SERVICE ADVISORY 18-318

Dometic Furnace Wiring

Limit Switch Wire Rework

Service Bulletin

1.1 Examining the limit switch wires

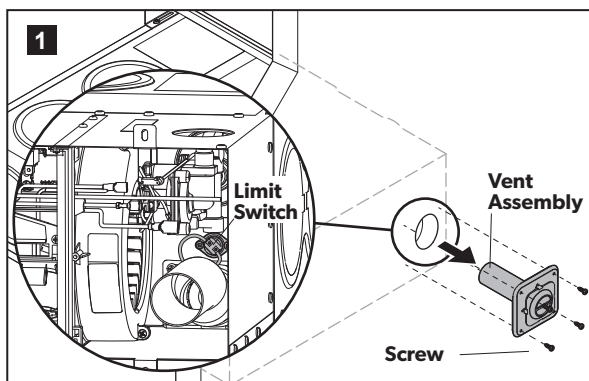
- Remove the vent assembly, and using a flashlight, look through the opening in the vent cover to inspect the exhaust vent area.
- Visually examine the limit switch wires for evidence of the following conditions:
 - Wires laying on the exhaust vent tube
 - Melting at any point along the length of the wire
- If either condition exists, contact the Dometic Technical Service department at 866-869-3118 to obtain authorization for removal of the furnace for replacement, prior to repairing any wires or continuing with this field repair.
- If no damage is present, proceed with this field repair.

1.2 Placing the sleeve on a DF/AF unit

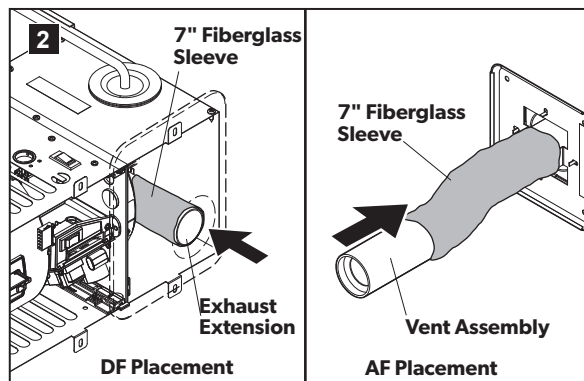
- Install the fiberglass sleeve:
 - For DF units: slide the fiberglass sleeve over the exhaust extension.
 - For AF units: slide the fiberglass sleeve over the vent assembly.
- Re-install the vent assembly.

1.1 Examining the limit switch wires

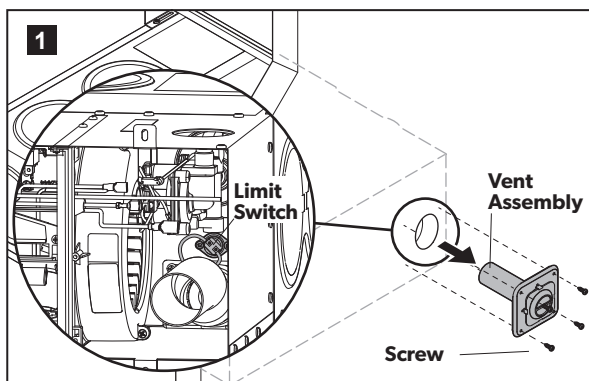
- Remove the vent assembly, and using a flashlight, look through the opening in the vent cover to inspect the exhaust vent area.
- Visually examine the limit switch wires for evidence of the following conditions:
 - Wires laying on the exhaust vent tube
 - Melting at any point along the length of the wire
- If either condition exists, contact the Dometic Technical Service department at 866-869-3118 to obtain authorization for removal of the furnace for replacement, prior to repairing any wires or continuing with this field repair.
- If no damage is present, proceed with this field repair.

1.2 Placing the sleeve on a DF/AF unit

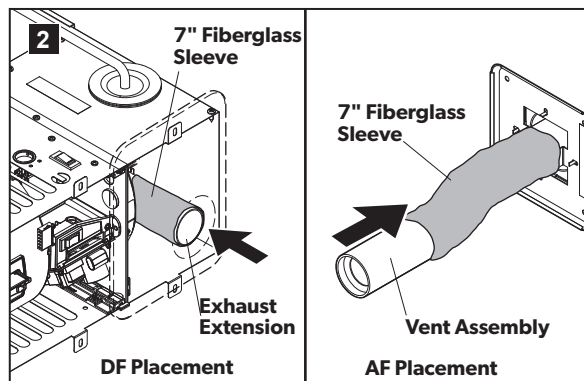
- Install the fiberglass sleeve:
 - For DF units: slide the fiberglass sleeve over the exhaust extension.
 - For AF units: slide the fiberglass sleeve over the vent assembly.
- Re-install the vent assembly.
